**Re: Sams Club Liquor Sales Add, 10600 Coors Blvd Bypass NW  
Grading and Drainage Plan  
Engineer's Stamp dated 4-19-06 (A13-D015)**

ENGINEER'S SEAL	ALBUQUERQUE SAM'S CLUB #4703 LIQUOR SALES ADDITION	DRAWN BY BJF
	GRADING AND DRAINAGE PLAN	DATE 04-19-06
	TERRA WEST, LLC 8509 JEFFERSON NE ALBUQUERQUE, NEW MEXICO 87113 (505)858-3100	25006GRB-02-21-05x
RONALD R. BOHANNAN P.E. #7868		SHEET # <b>C4</b>
		JOB # 25006

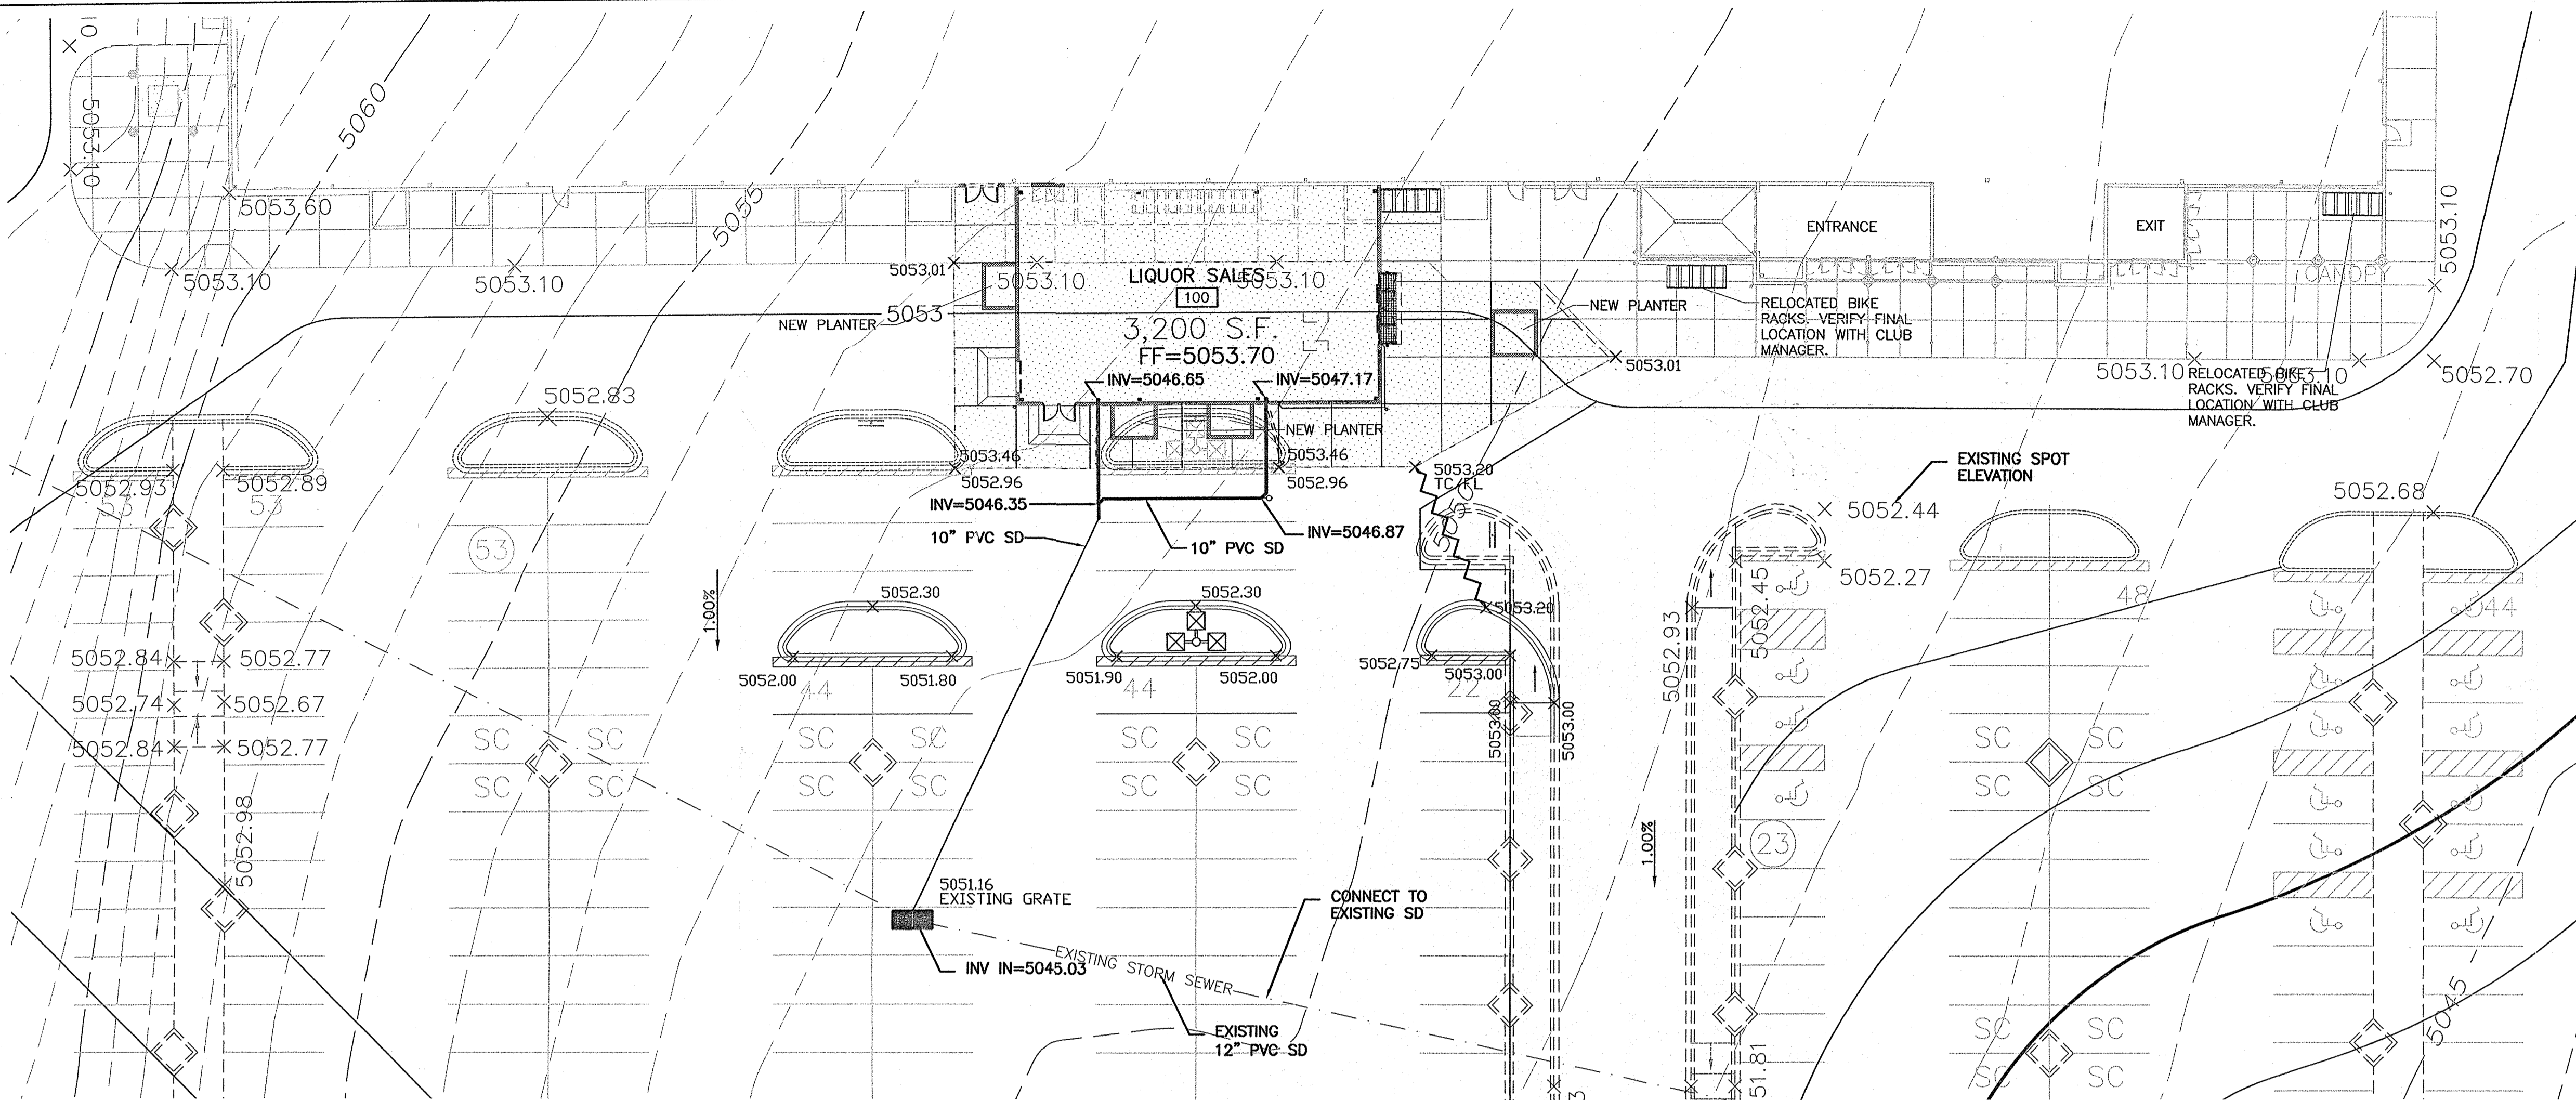
Based upon the information provided in your submittal received 4-20-06, the above referenced plan is approved for Grading and Building Permit. Please attach a copy of this approved plan to the construction sets prior to sign-off by Hydrology. **Prior to Certificate of Occupancy release, Engineer Certification per the DPM checklist will be required.**
